November 20, 1984

Joseph M. Farley Nuclear Plant - Units 1 and 2  
Detailed Control Room Design Review (DCRDR)

APCo Response to NRC  
Comments on DCRDR, Dated March 9, 1984

Figure 1  
Farley Nuclear Plant

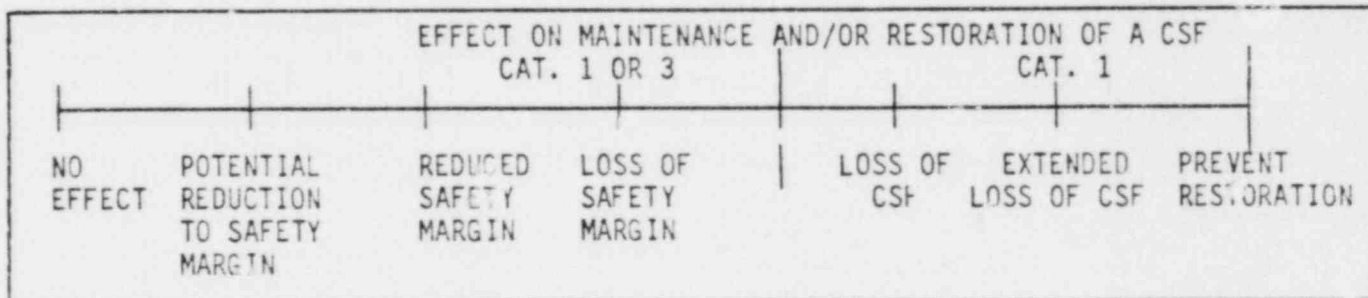
2. NRC Comment: The NRC Staff had the following comments on the APCo real-time simulation approach to task analysis:
- a) Procedures for a complete function and task analysis at a detailed level are not included in the APCo program plan (reference Section 3.4 of NUREG-0700). The Staff concludes that both "Event-Related Guidelines" and "Function-Related Guidelines" are necessary to cover all emergency operations.

- b) The method for identifying information and control requirements for emergency plant operation is not explicitly addressed in the APCo program plan. Procedures need to be developed for the system function analysis and the identification and evaluation of information and controls required by the operator to meet tasks responsibilities.

- c) Procedures for generating a control room inventory have not been explicitly defined. It is not clear how the instrumentation defined in the ERP's can be systematically checked during a real-time simulation using the ERP's. The time available to the operators for each task in a real-time simulation is limited.

- d) The data collection forms for documenting task information (i.e., the Task Sequence Charts) do not indicate that information and control requirements will be defined.

APCo Response: APCo has revised the DCRDR task analysis to more readily address the NRC staff concerns related primarily to information and control requirements. A description of the revised task analysis which includes the process for identifying the characteristics of needed instrumentation and controls is provided below.

The output of the table-top analysis will be recorded on Task Analysis Worksheets (TAW's) which provide an auditable means to document information and controls requirements and the corresponding instrumentation and controls. The TAW's will serve as an auditable record of how the needed characteristics of the instruments and controls were determined. An example TAW form is provided as Figure 1.

Figure 2  
Farley Nuclear Plant  
CHECKLIST/SURVEY WORKSHEET

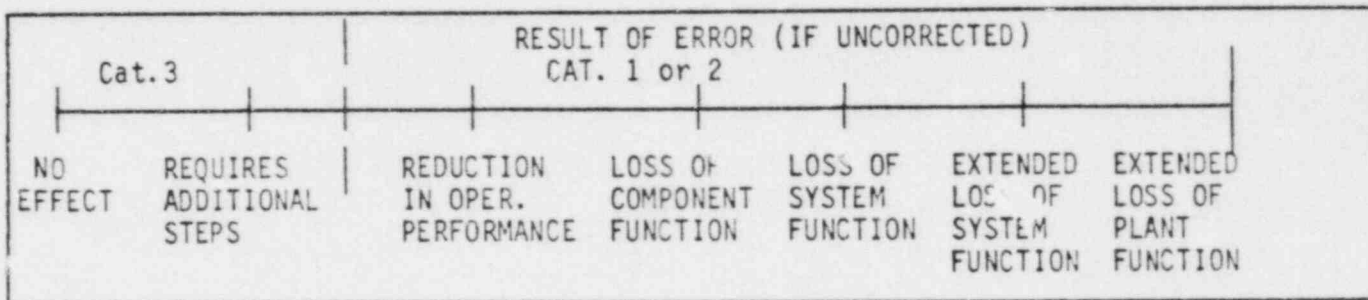
3. NRC Comment: The sample Checklist/Survey worksheets enclosed in the APCo program plan appear to lack space for recording the nomenclature/location of the discrepant item(s) involved.

APCo Response: The worksheets have been revised so that all discrepant items can be identified by panel location and instrument number. An example worksheet is provided as Figure 2.

Figure 3  
Farley Nuclear Plant  
CONTROL ROOM DESIGN REVIEW

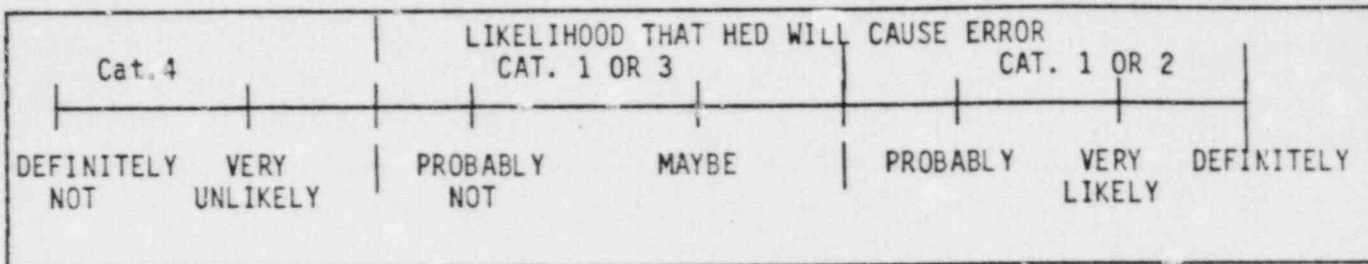
6. NRC Comment: Although the APCo program plan mentions the use of consensus opinion and use of an INPO NUTAC document to rate HED's, the plan does not include a precise method to systematically assess HED's for significance. The Staff recommends that further documentation be provided to demonstrate that a concrete and valid technique will be employed.

APCo Response: The method for HED assessment will include the use of several rating scales. Each HED will be rated on every scale by as many voting DCRDR team members as possible. These scales will be 7-point Likert-type scales from which an HED can be consistently categorized as to its potential for causing serious operator error. An example HED assessment form is provided as Figure 3. The details of the assessment method will be included in the DCRDR summary report.
